January 19, 2011

**Subject: Modification of 100% Design Submittal  
Operable Unit 1  
Fletcher's Paint Works and Storage Facility Superfund Site  
CERCLA Docket No. 01-2001-0063  
Milford, New Hampshire**

ARCADIS U.S., Inc. (ARCADIS) has reviewed the Final Design Report and made the modifications necessary to adjust the depth of excavation cell V to conform to the correct seasonal low water table elevation. The following modifications to the Final Design Report are attached:

FINAL (100%) DESIGN REPORT  
FLETCHER'S PAINT WORKS AND STORAGE FACILITY SUPERFUND SITE  
GENERAL ELECTRIC COMPANY - MILFORD, NEW HAMPSHIRE  
(Results are presented in parts per billion, ppb)

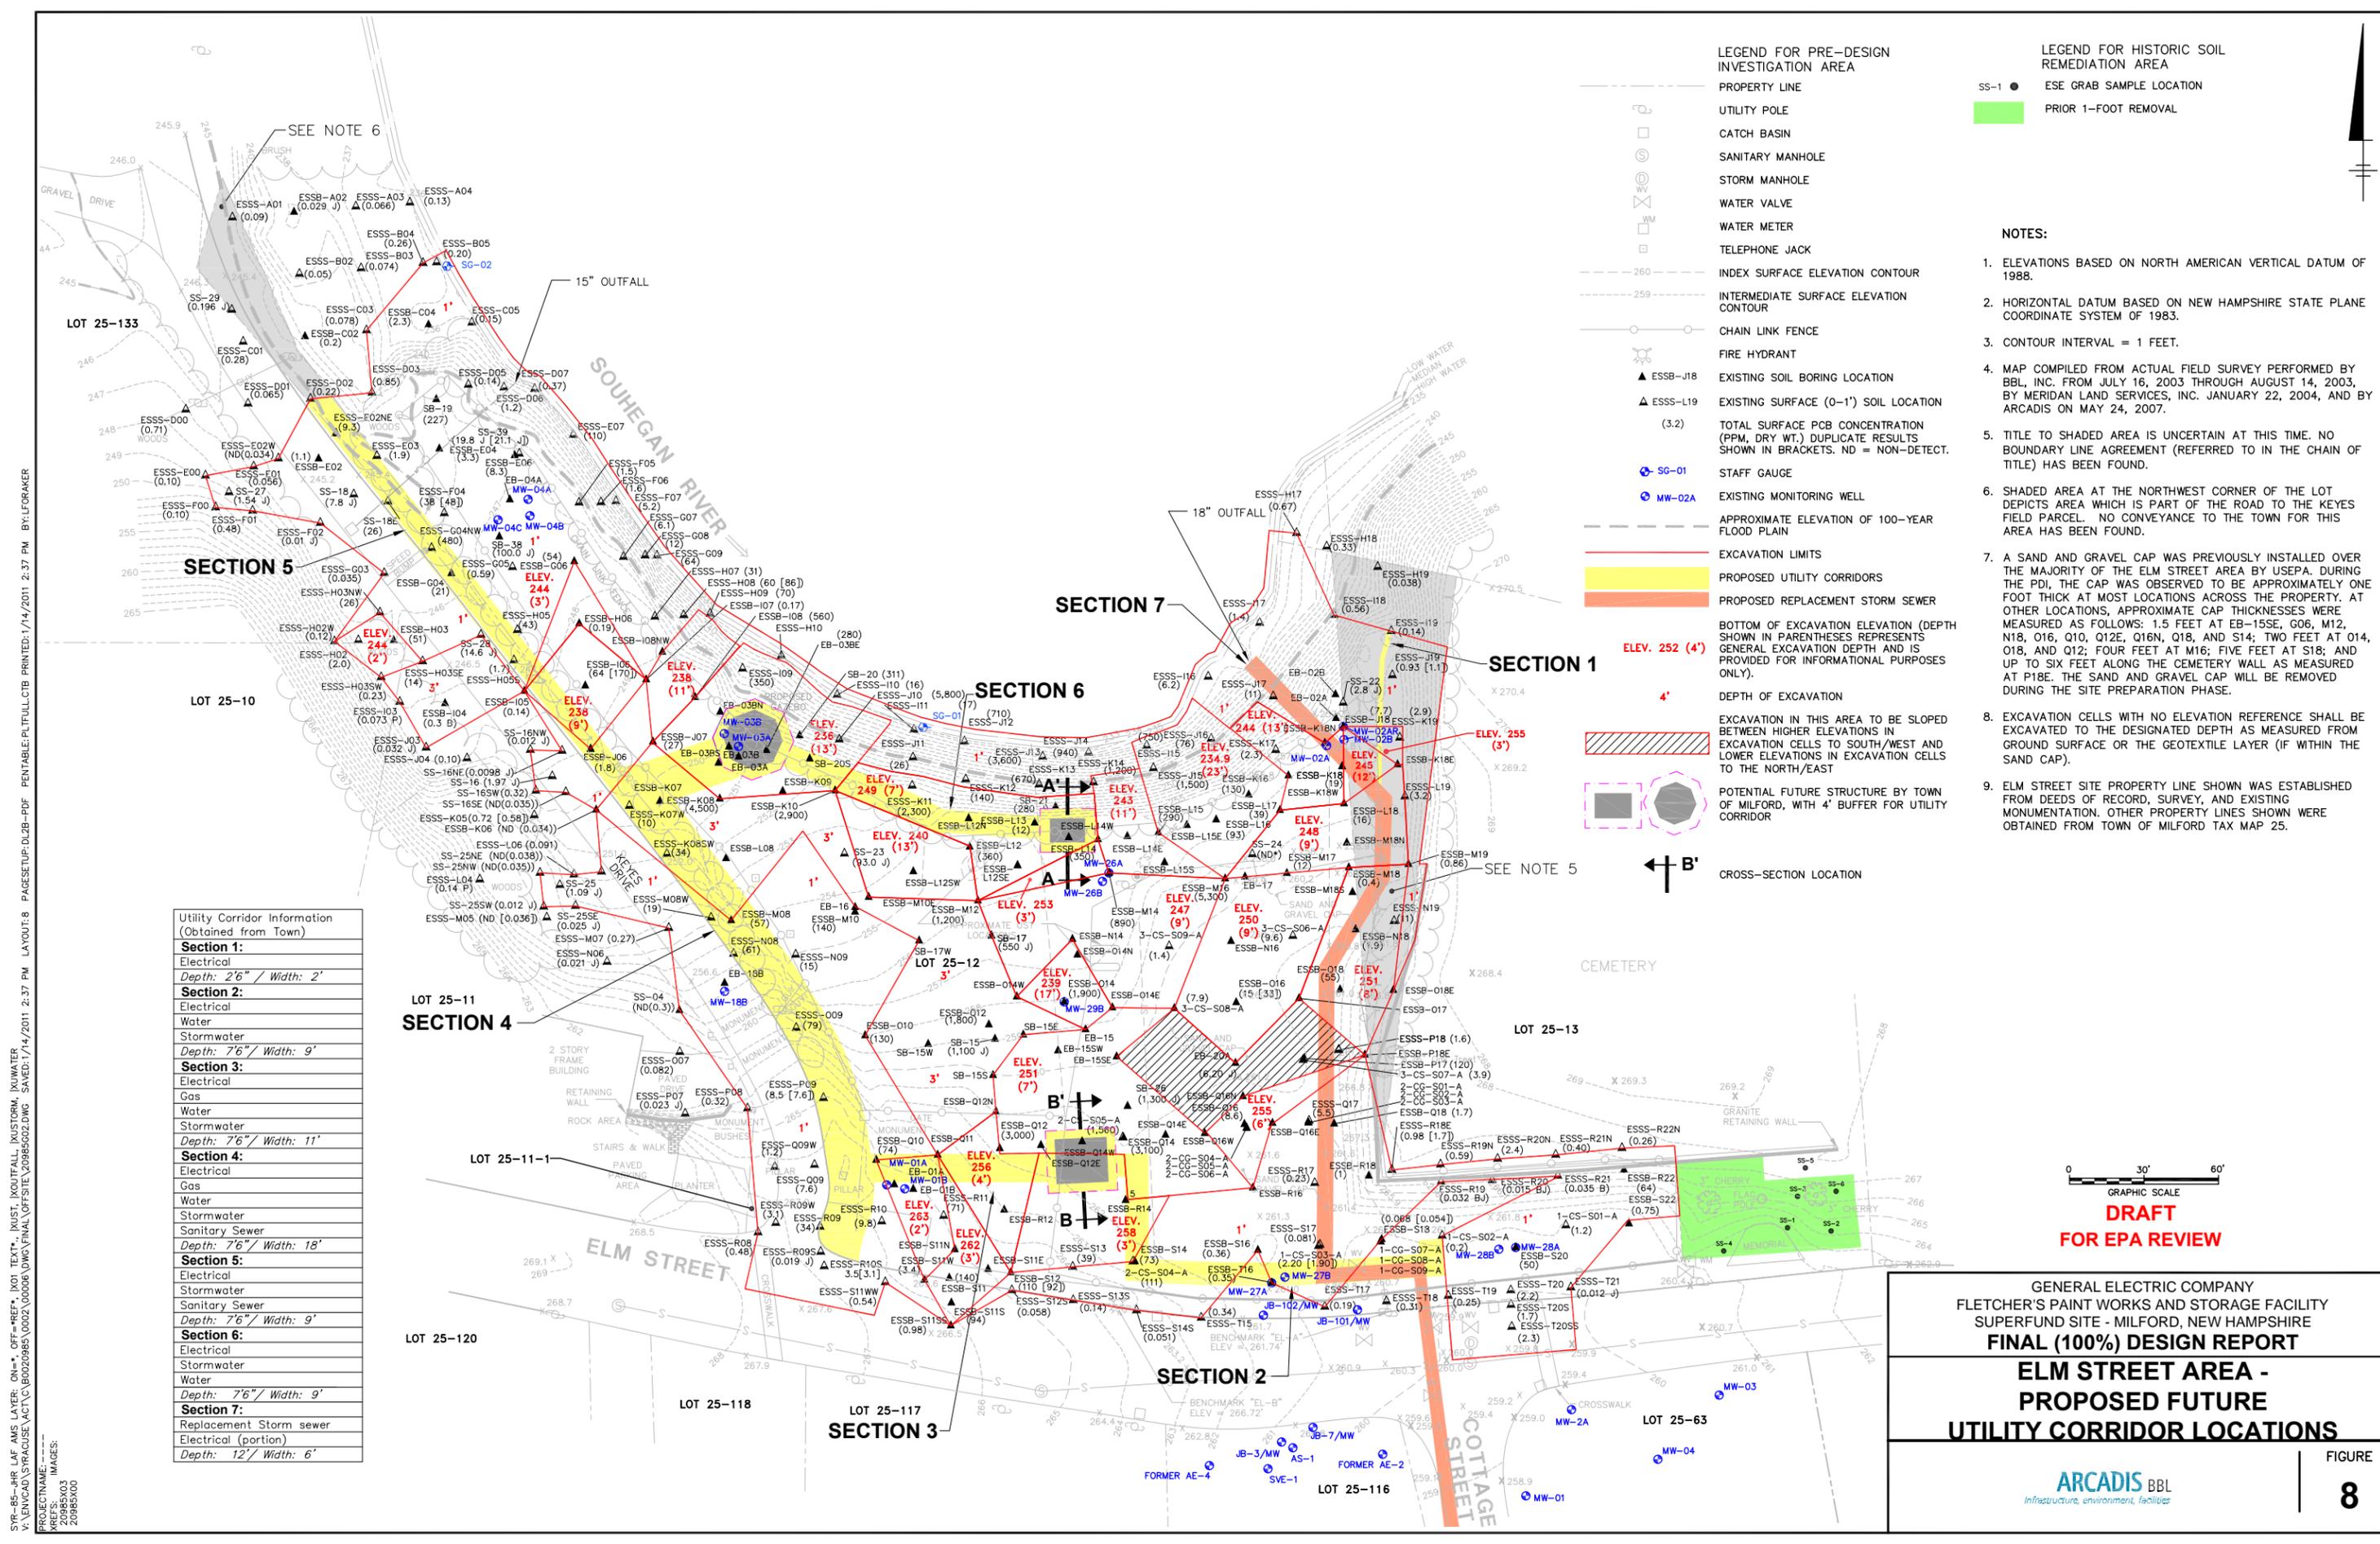
- Revision of Table 11 of Volume I of the Final Design Report to provide the corrected water-level elevation data, as discussed in my September 31, 2010 letter, updated to also include the data from the October 2010 monitoring event;

FIGURE  
**A-1**

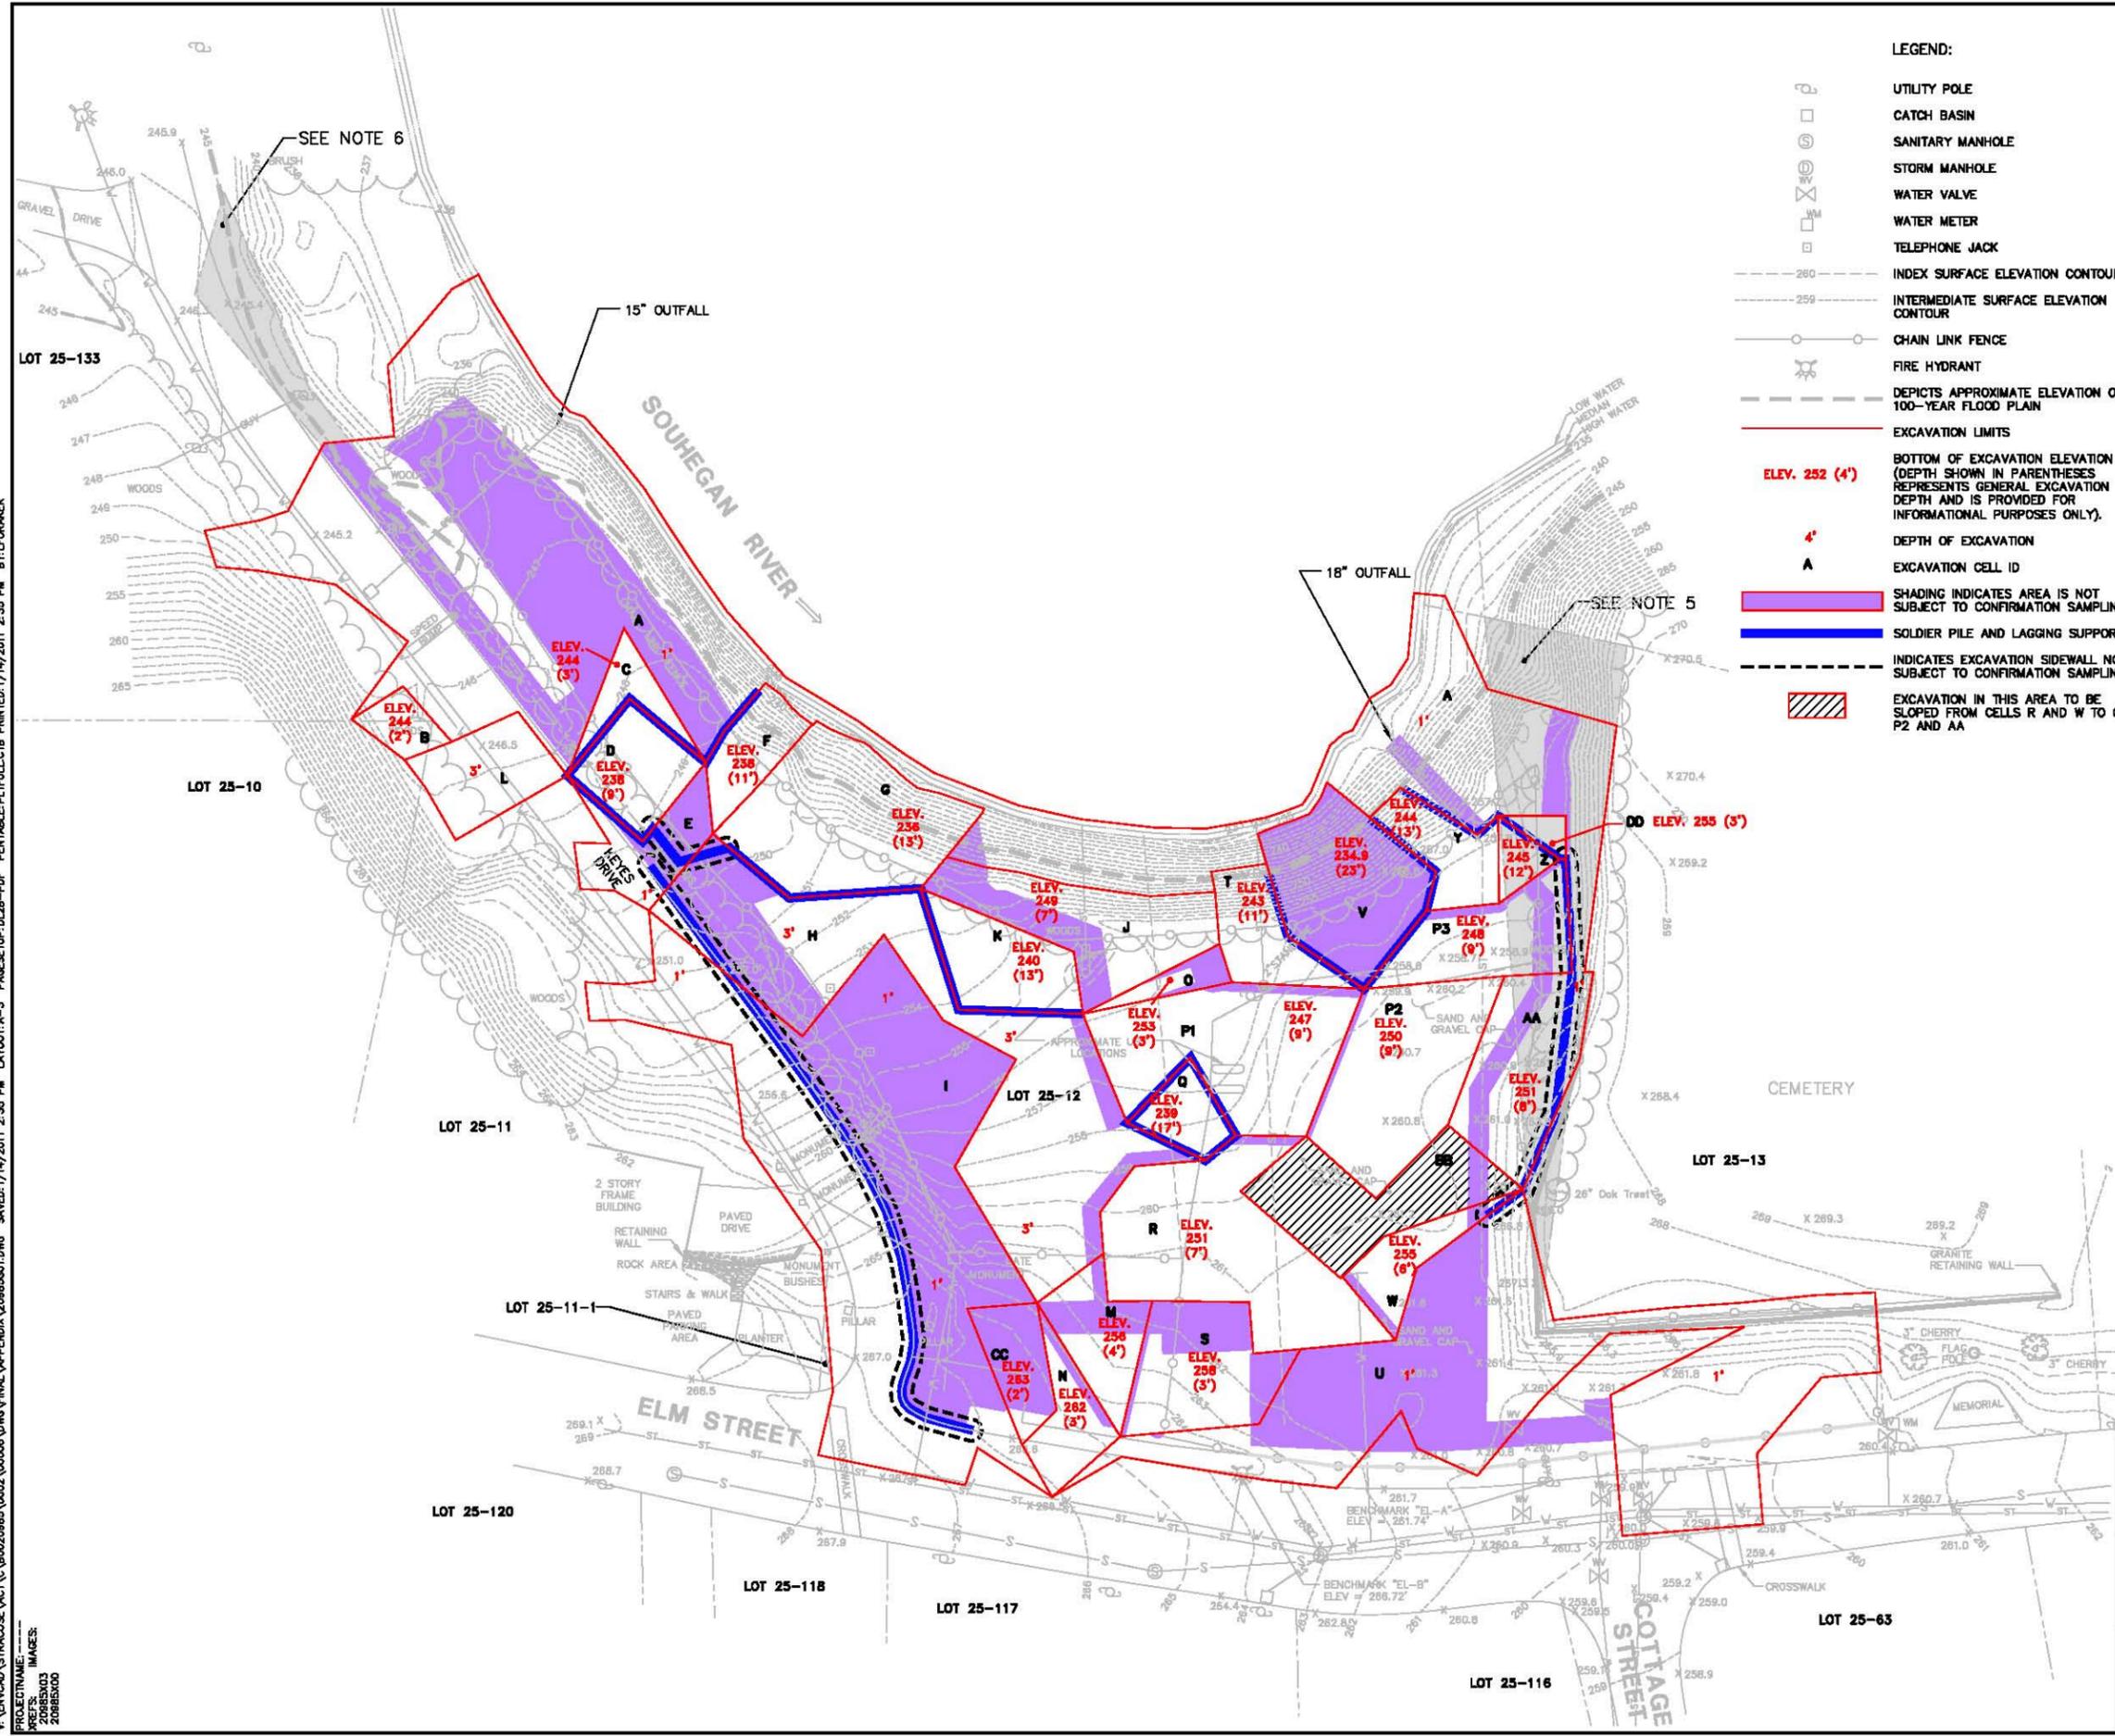
- Revision of Figures A-1, A-3, A-6, A-7 and A-18 in Appendix A of Volume II of the Final Design Report to reflect a change to the base of excavation cell V based on the correct seasonal low water-table elevation, and related changes to the 1-foot excavation cell(s) to the north, northeast and northwest of cell V;

GENERAL ELECTRIC COMPANY FLETCHER'S PAINT WORKS AND STORAGE FACILITY SUPERFUND SITE - MILFORD, NEW HAMPSHIRE <b>FINAL (100%) DESIGN REPORT</b>
<b>ELM STREET AREA - VERIFICATION                  AREA 9</b>
FIGURE <b>A-16</b>

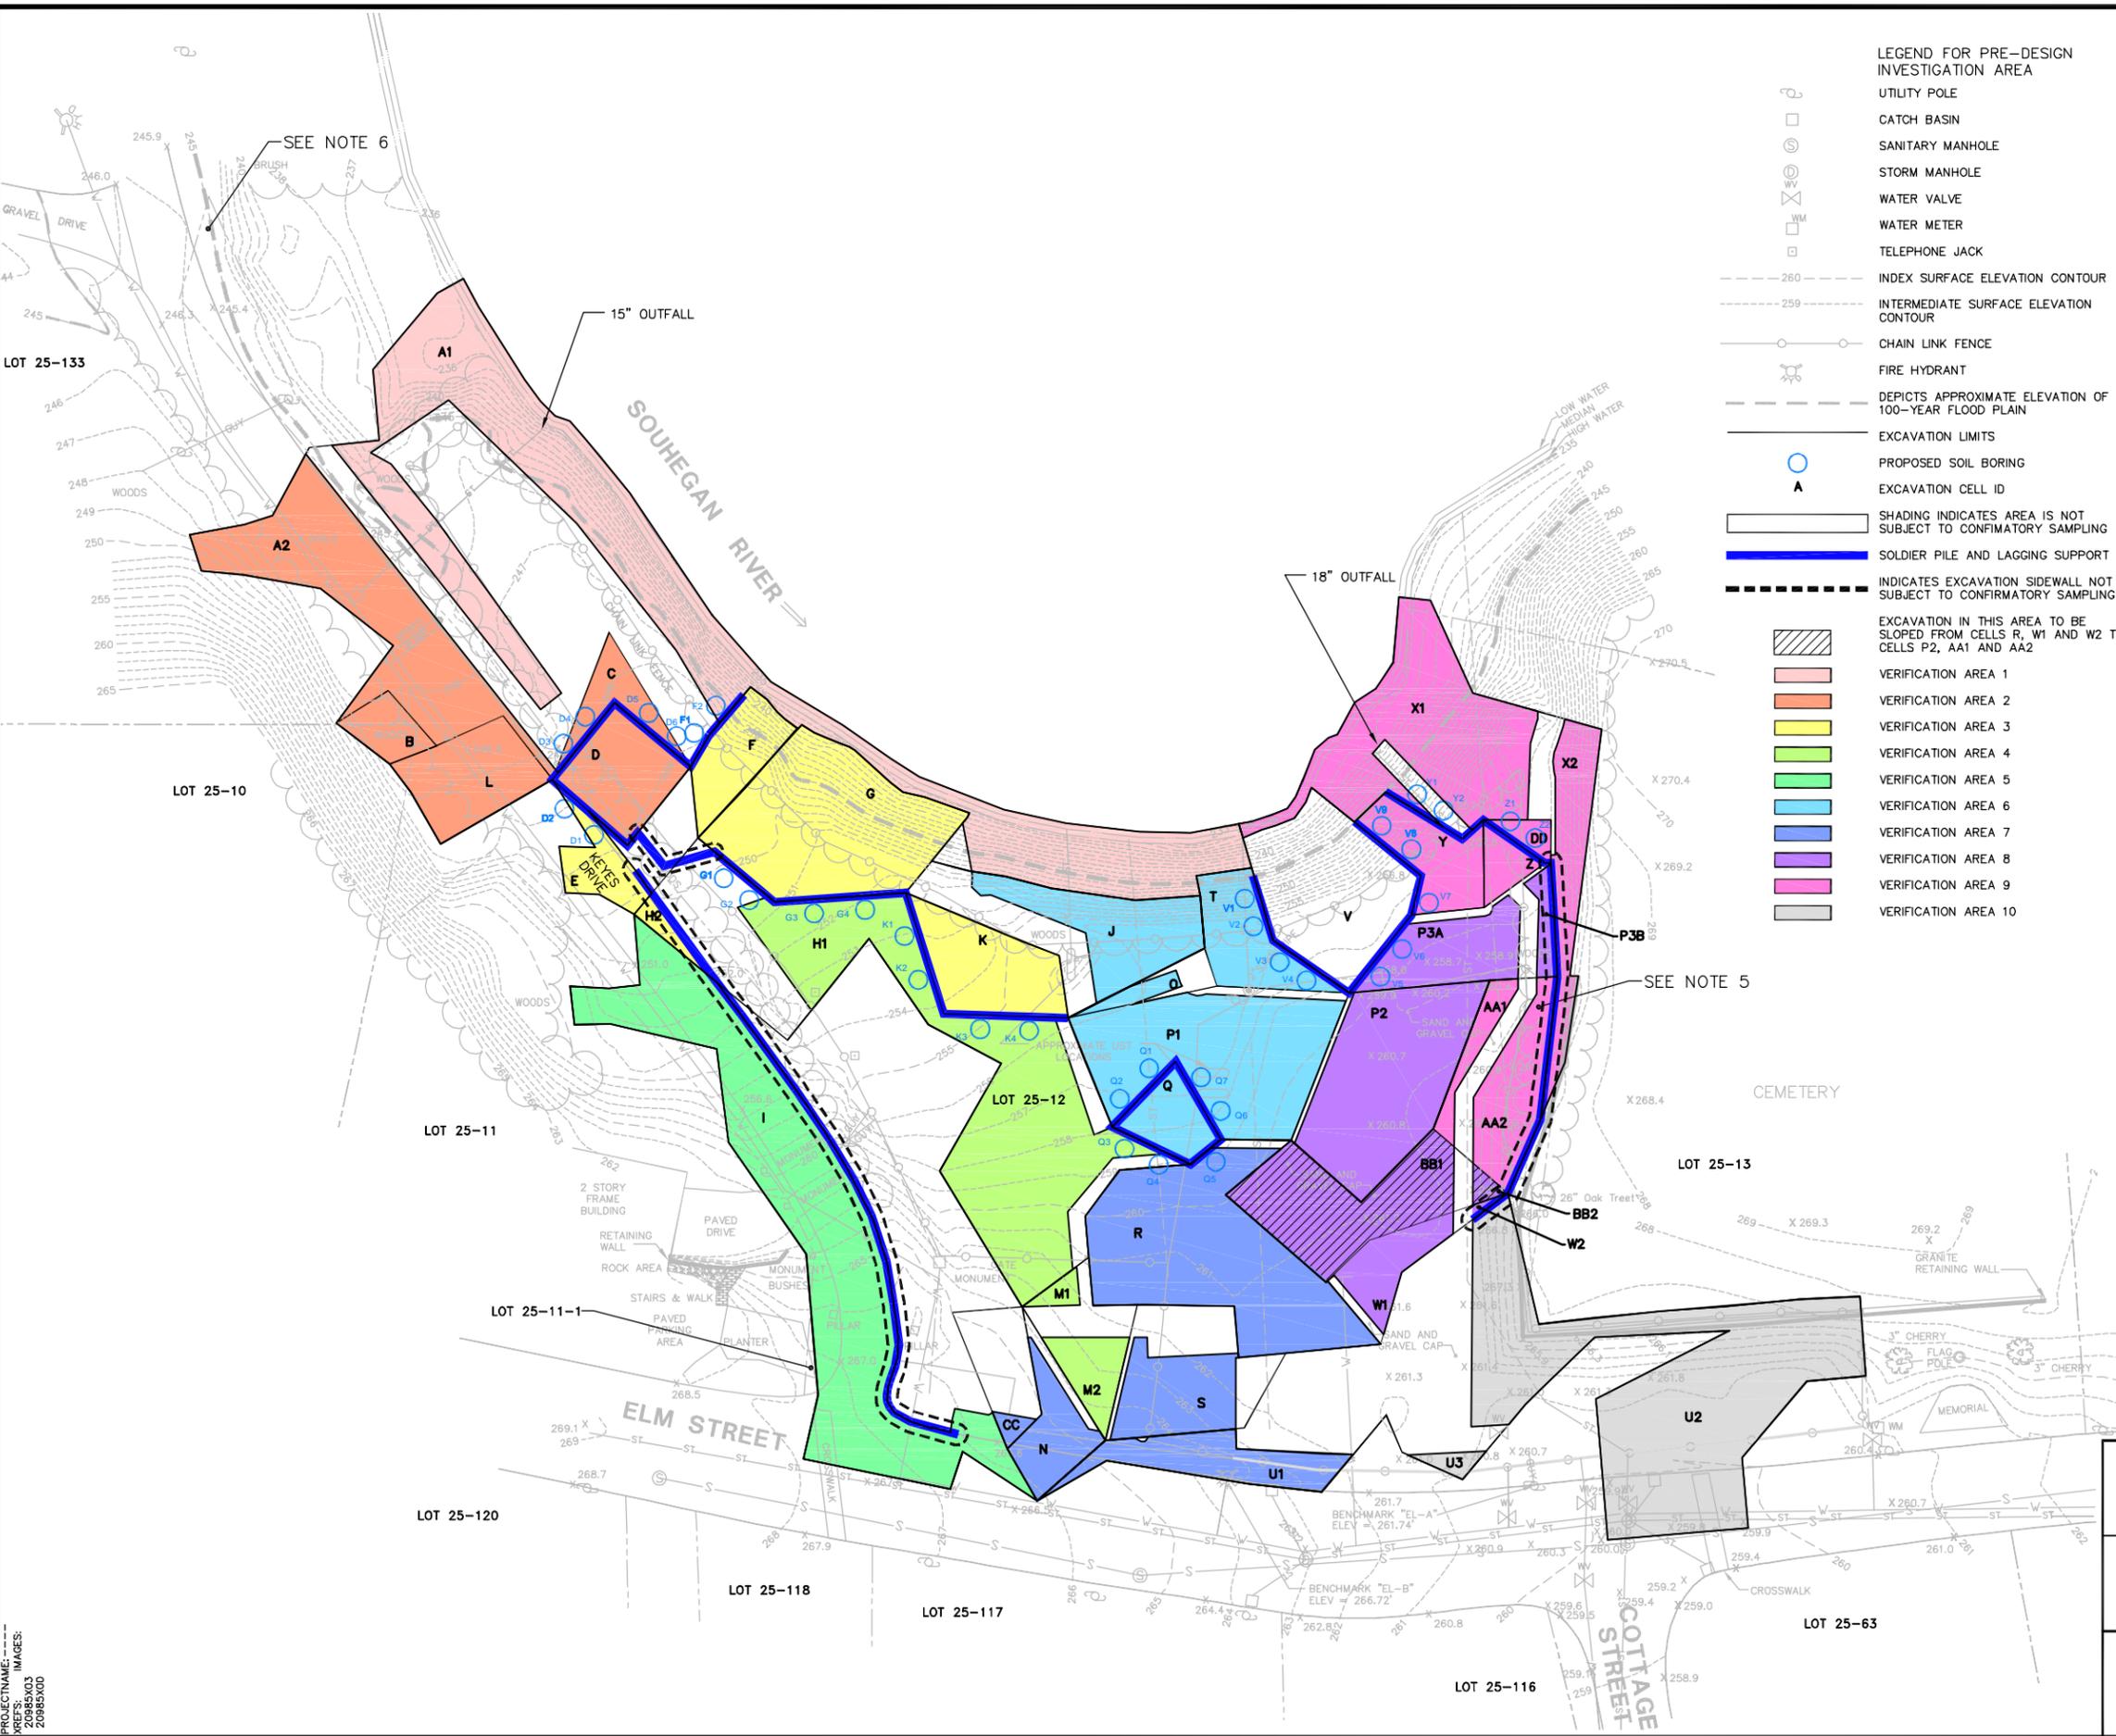
- Revision of Figure A-16 in Appendix A of Volume II of the Final Design Report to reflect incorporation of a portion of former excavation cell V (immediately adjacent to the river's edge) into verification area 9;
